**BARR ENGINEERING CO.**  
CONSULTING ENGINEERS

August 25, 1983

This letter summarizes our recommendations for a remedial action plan at the solvent disposal site on the Henkel property. Our recommendations are consistent with the discussion with the MPCA on July 12, meetings in your office since that time, and with the MPCA's August 2, 1983 letter. While the MPCA favors some type of source control, it is evident that the Agency also favors remedial measures and additional investigations of the Platteville aquifer to limit the migration of contamination to the lower aquifers.

Figure 1  
RECOMMENDED LOCATIONS  
FOR ADDITIONAL PLATTEVILLE  
CARIMONA WELLS

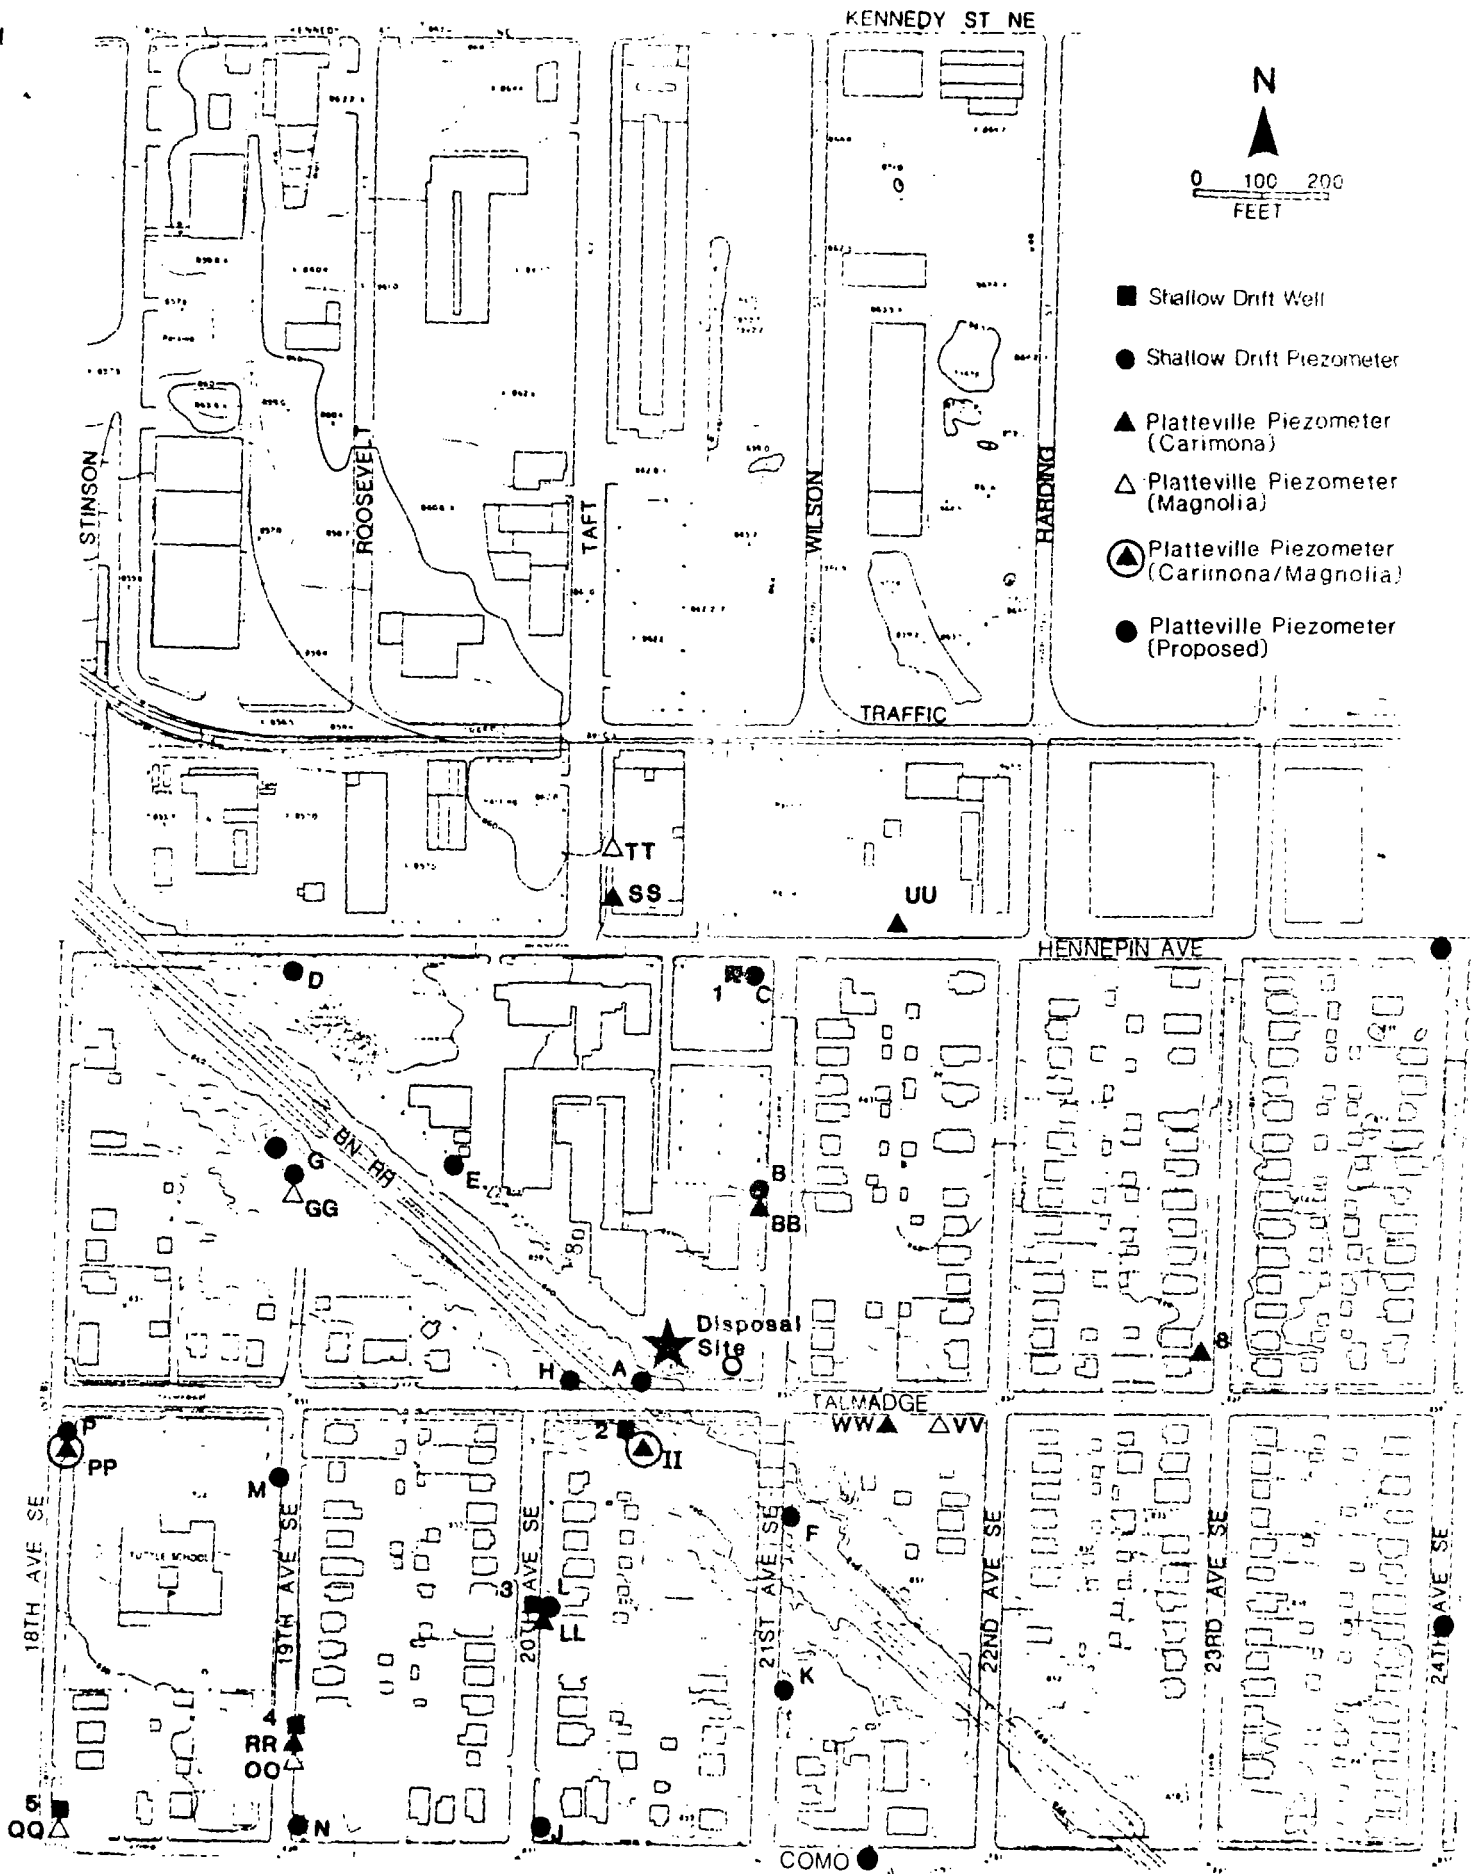
4. Place Additional Platteville Monitoring Wells -- Additional Platteville monitoring wells are recommended at the four locations shown in Figure 1 accompanying this letter. The purpose of these wells is to define solvent concentrations in the Carimona at locations east and south of the site. This information is needed to better define the area that must be captured by the Platteville pump-out system. If samples from these wells show low concentrations of solvents, the wells will be important components of the eventual groundwater monitoring system. As shown, one additional Platteville monitoring well is also recommended northwest of the site to better define piezometric levels in that area.
